IEEE P802.15 Wireless Personal Area Networks

Title: Proposed Comment Resolution of the MR-O-QPSK PHY

Re: Task Group 15.4g LB51 comment resolution
Abstract: Comment resolutions for the MR-O-QPSK PHY

CID 1470

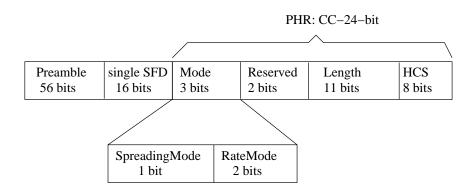
- During PHR reduce spreading gain but introduce FEC.
- Response:
 - Accept.
- Resolution:
 - ▶ FEC based on terminated and interleaved convolutional coding
 - Option B
 - pilots in order to simplify Viterbi decoding
 - For details see doc # 15-10-0435-02-004g
